EMAIL AND ATTACHED RESPONSE TO U S EPA REGION V COMMENTS REGARDING
THE PASSIVE TREATMENT SYSTEM AT SPRINGS A AND C FOR THE CORRECTIVE
MEASURES PROPOSAL SOLID WASTE MANAGEMENT UNIT 3 (SWMU 3) AMMUNITION
BURNING GROUNDS NSA CRANE IN
05/27/2015
NAVFAC MID ATLANTIC

Follow-on US EPA Region 5 Comment Dated 09/04/14
NSA Crane SWMU 3 Ammunition Burning Grounds
Corrective Measures Proposal

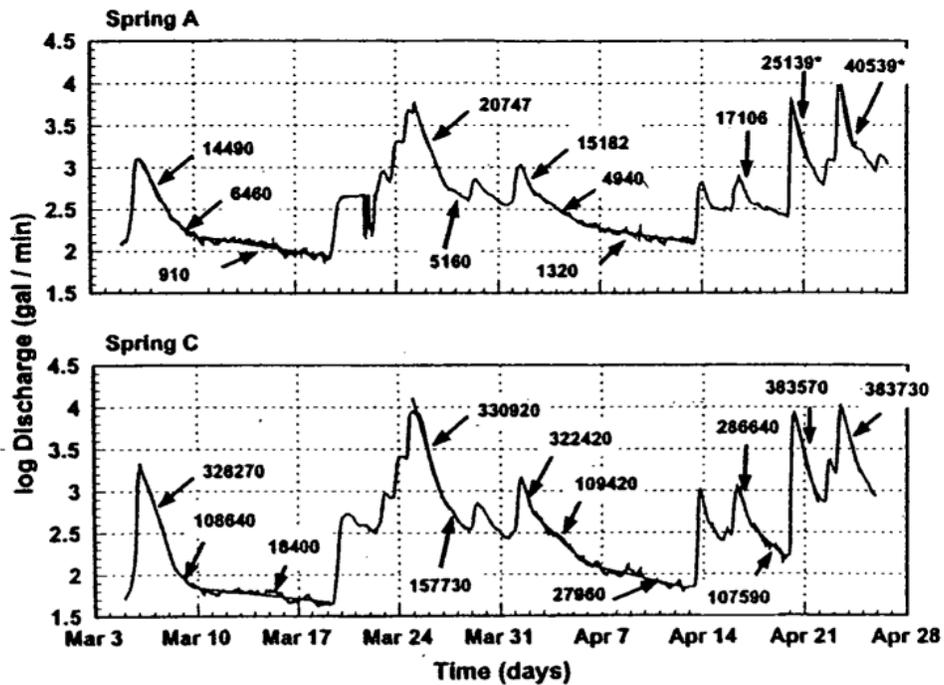
Comment: What is the feasibility of a passive treatment system at springs A and C?

Response: Passive treatment of RDX contamination in Springs A and C is not considered to be feasible and was not considered in the Corrective Measures Proposal (CMP) to address low level concentrations of RDX ranging from non-detectable to approximately 140 micrograms per liter (ug/L) in the springs.

Actual variations in flow rate would be a major consideration with passive treatment options such as constructed wetlands or carbon filtration. In March and April 1996, continuous flow measurements were conducted for Springs A and C (Baedke, 2002). During these measurements, the flow rates of Springs A and C rose rapidly in response to rain events and declined fairly rapidly within a few days. At low flow, discharges from the springs were a few gallons per minute. The peak flows in each of the two springs during the 2-month time period were estimated to be well in excess of 10,000 gallons per minute (gpm) or 22.3 cubic feet per second (ft³/s), when the capacity of the flow measuring devices was exceeded. The attached Figure 14 shows the hydrographs. These flow estimates are consistent with previous reports (e.g., Hunt, 1988; Murphy and Ciocco, 1990) that indicated the springs become turbid during high flow events and then clear up and return to normal flow within a day or two after a storm event.

These measurements considered only Springs A and C flow rates into Little Sulphur Creek (LSC). They did not take into account surface storm water flow going directly into LSC and flow from other springs discharging into LSC. These flow rates would only be significant during high precipitation events and would be expected to exceed flows from Springs A and C.

The extreme variations in the spring discharge and LSC surface water flow present a significant impact on the feasibility of passive treatment such as a wetlands system at both Springs A and C.
